Re: Letter of Correspondence #2
Site Plan Review
Shared Maintenance Facility
185 Windham Center Road, Windham, Maine

The following narrative addresses comments received from Jonathan Earle, Town Engineer concerning the fueling station siting option and the stream buffer impacts.

POSTDEVELOPMENT
WATERSHED MAP

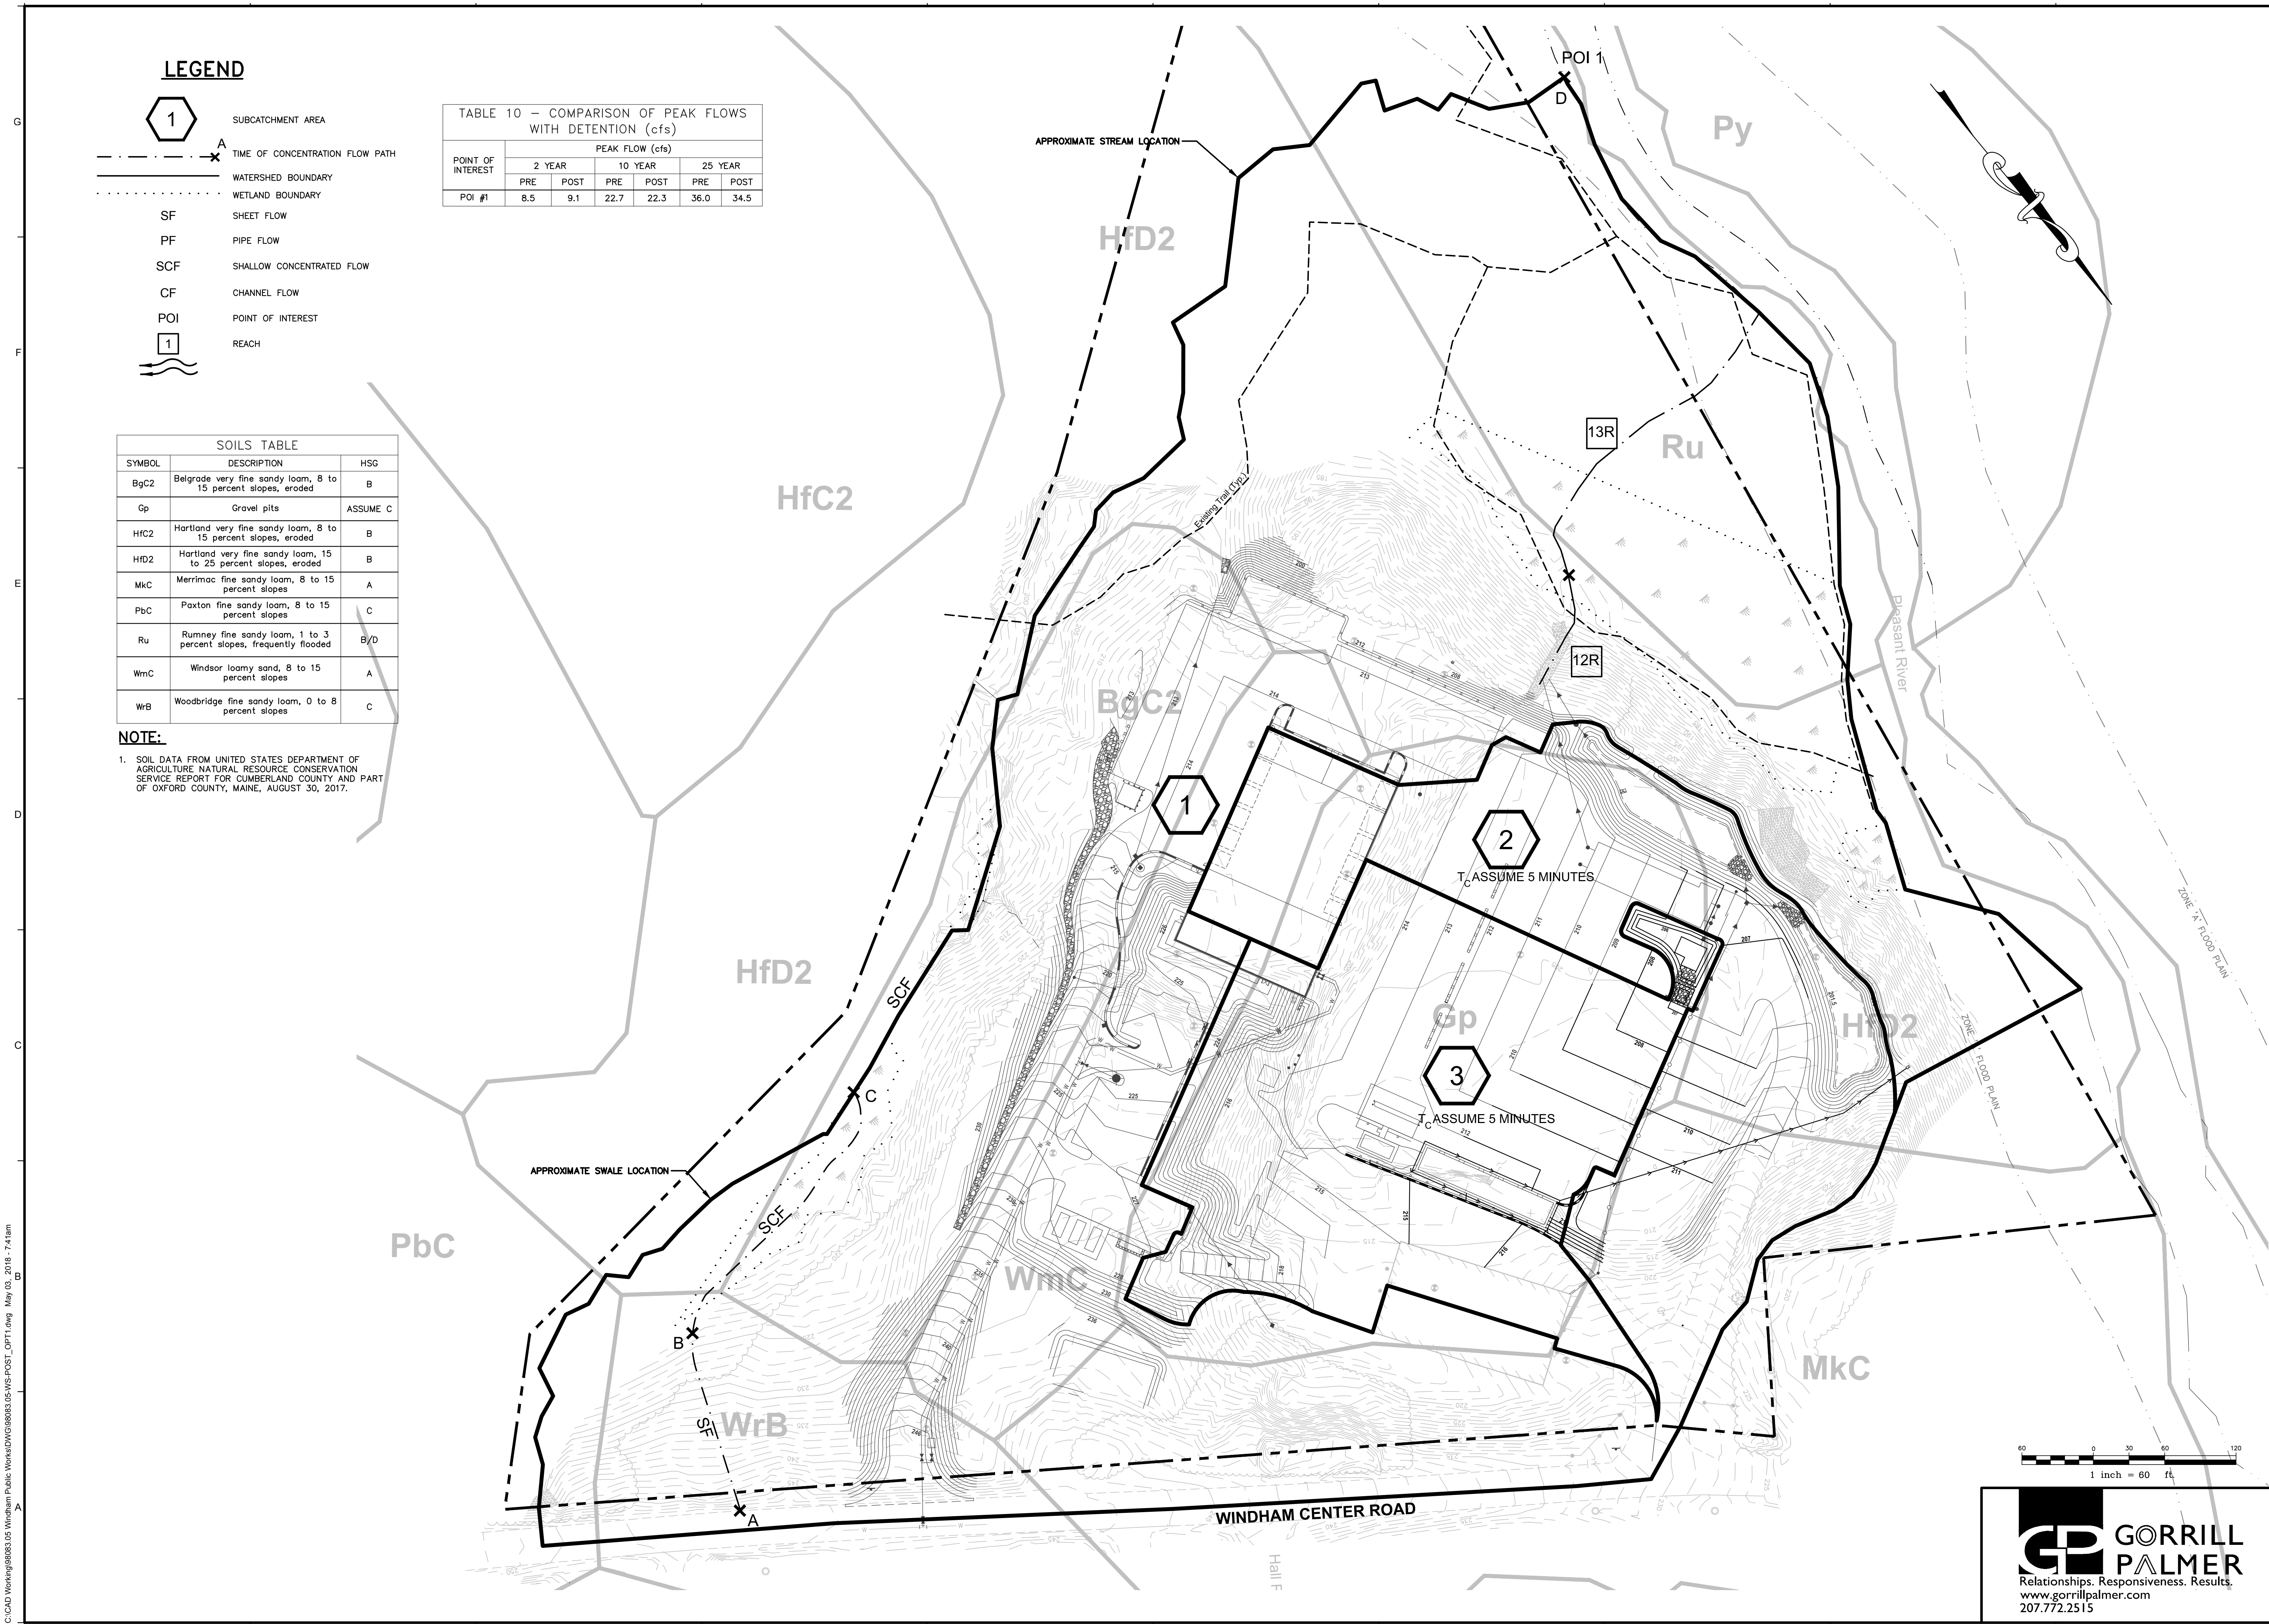
Comment - *Provide a revised postdevelopment watershed map that includes the revised location of the fuel station. The grading plan clearly shows the footprint is tributary to the Focal Point device, but it would be good to show this on the watershed map as well.*

Response – A revised post-development watershed map is attached to this letter.

Drawing Name:
Existing Stream Buffer

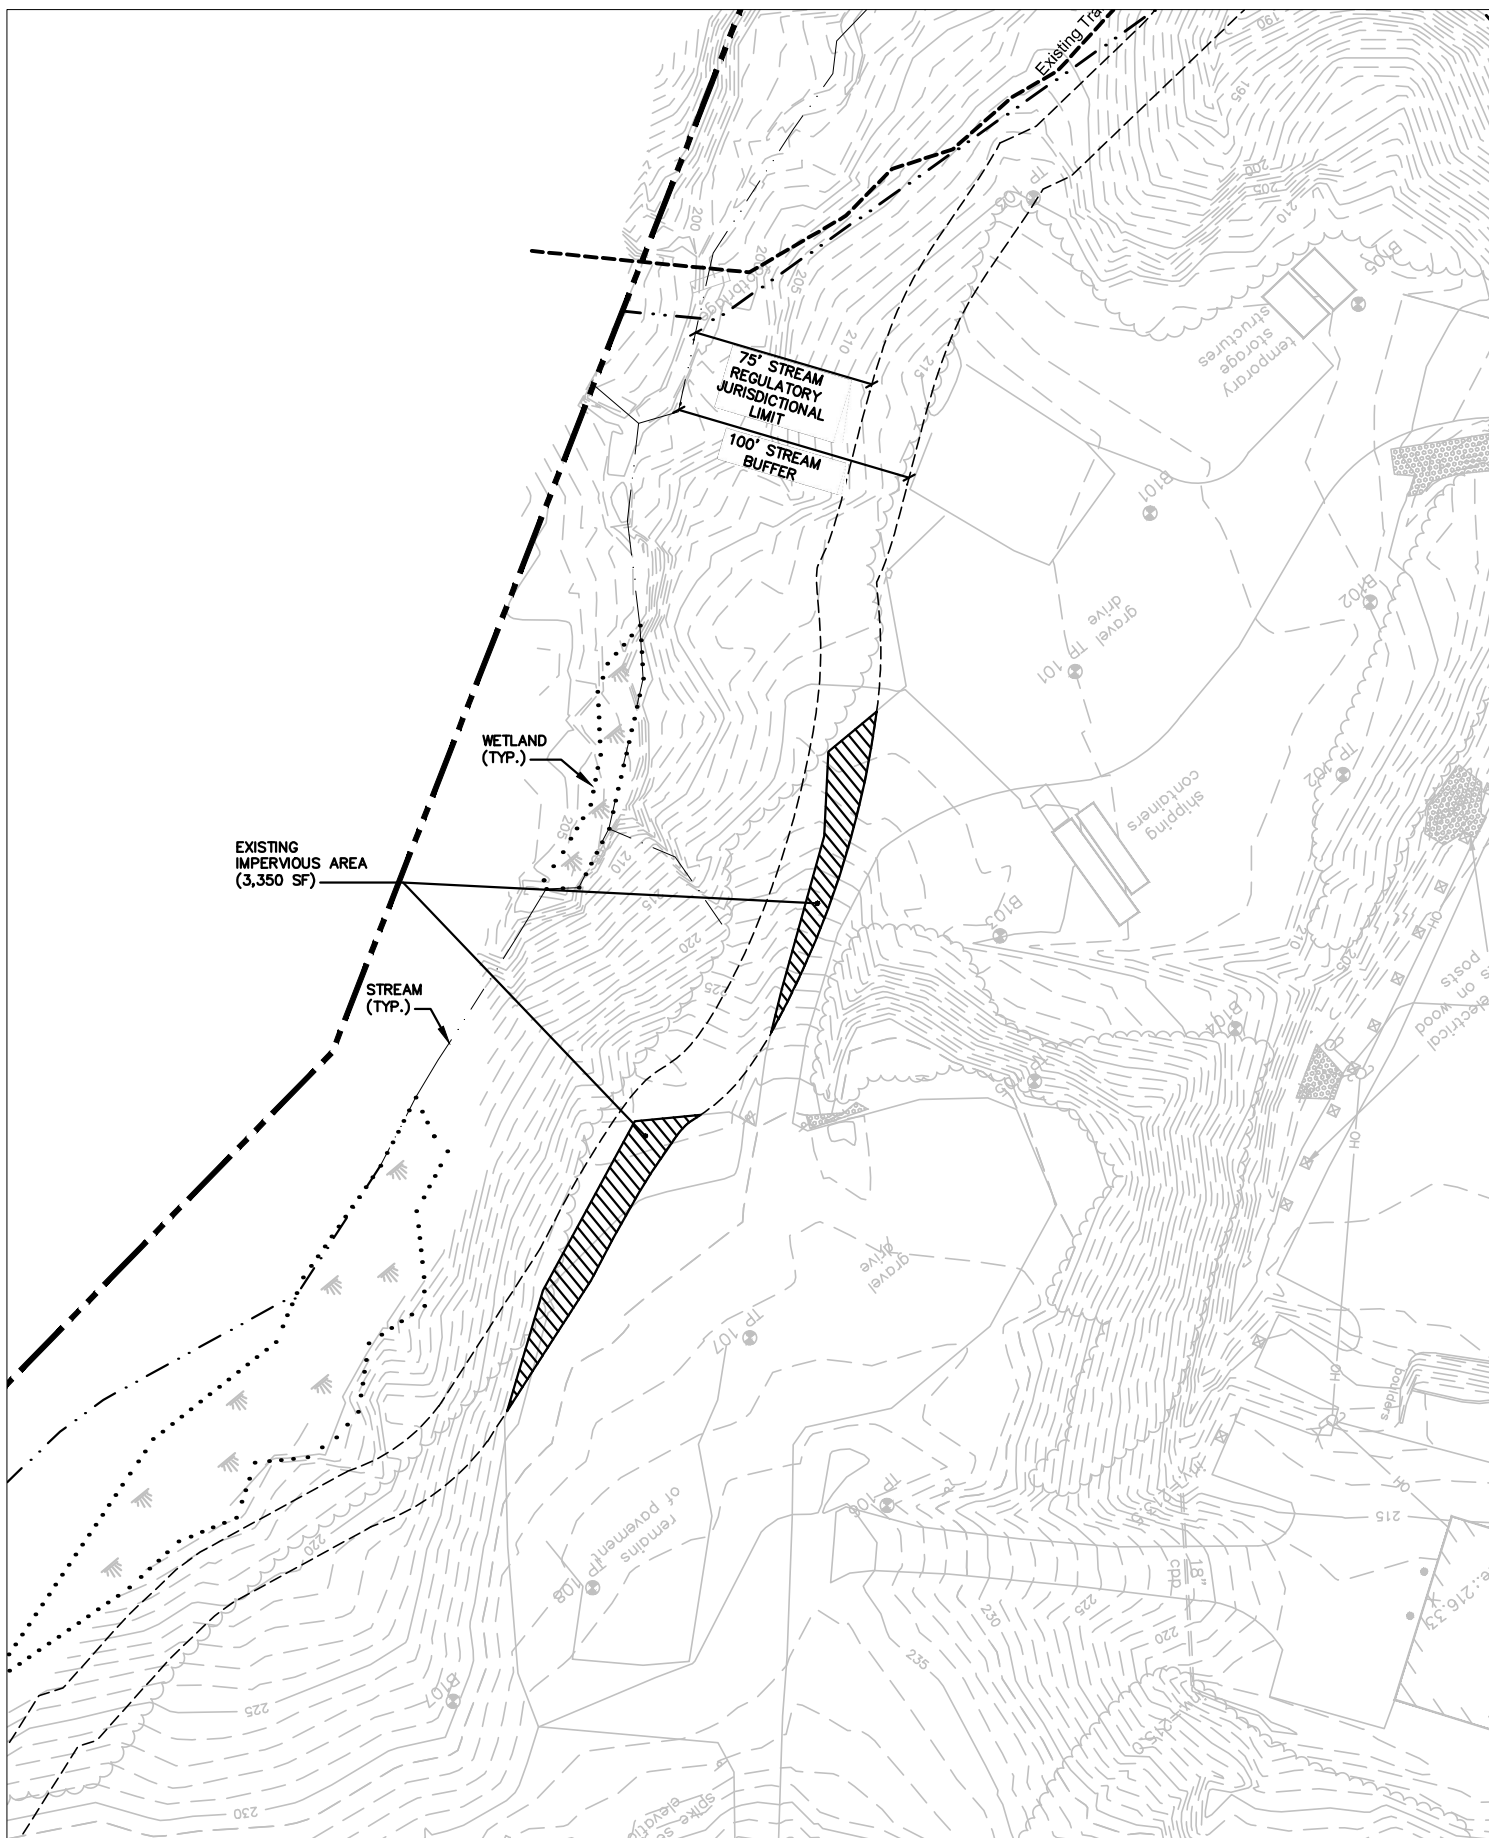
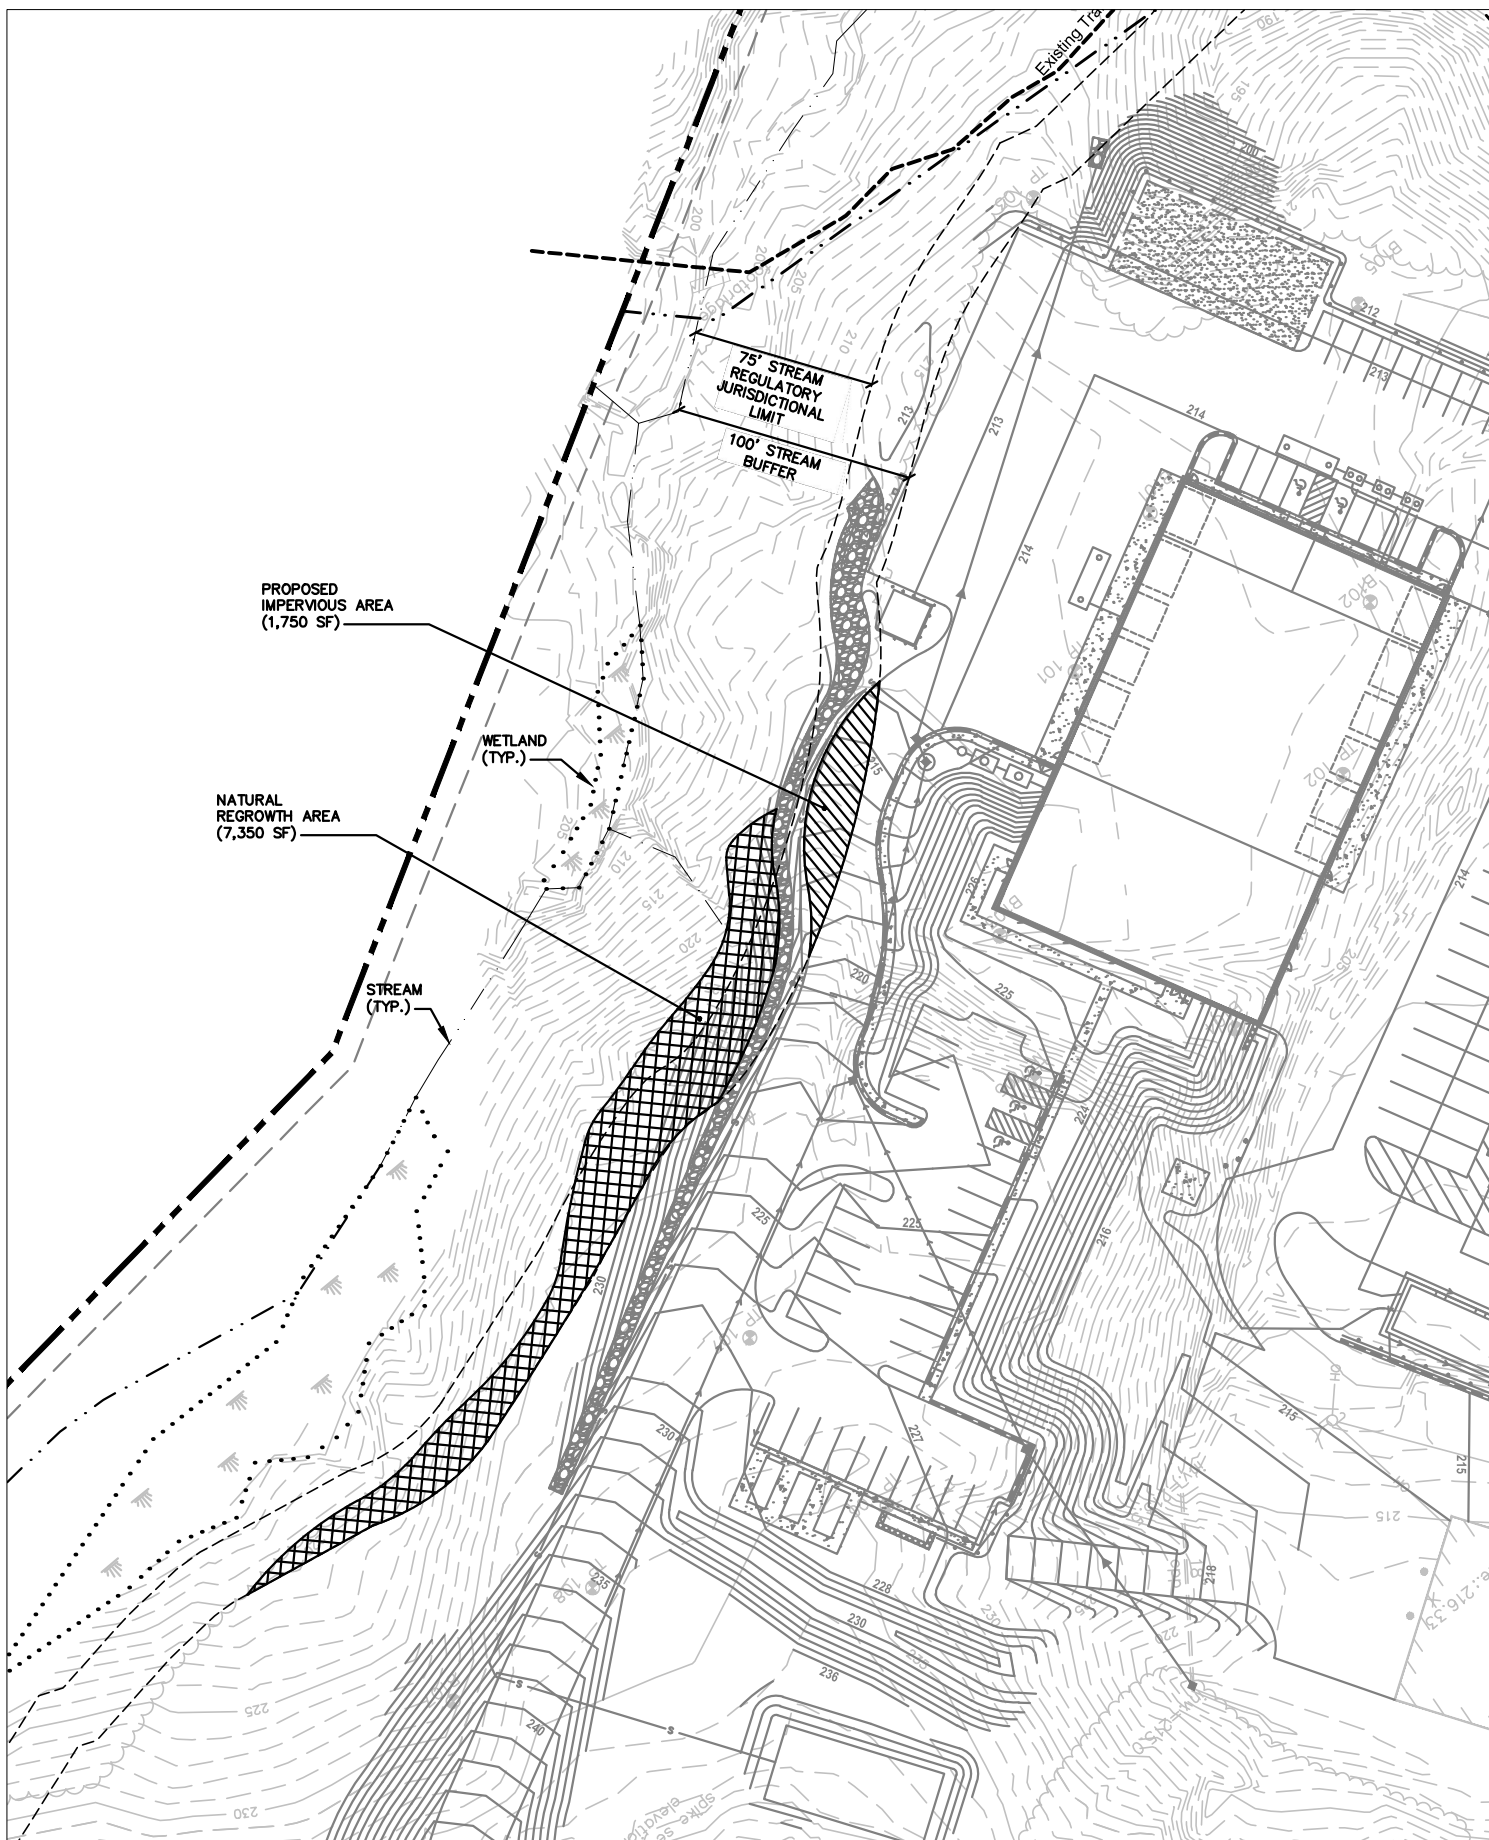
Comment - *You make a great point that the project is actually resulting in less impervious and disturbed area with the 75' buffer. Would it be helpful to show this on a plan (or two plans?) to give the Board a visual on the reduced buffer impacts. Not something I need to see or review, just a suggestion.*

Response – Plans depicting the buffer change as a result of this project are attached to this letter.
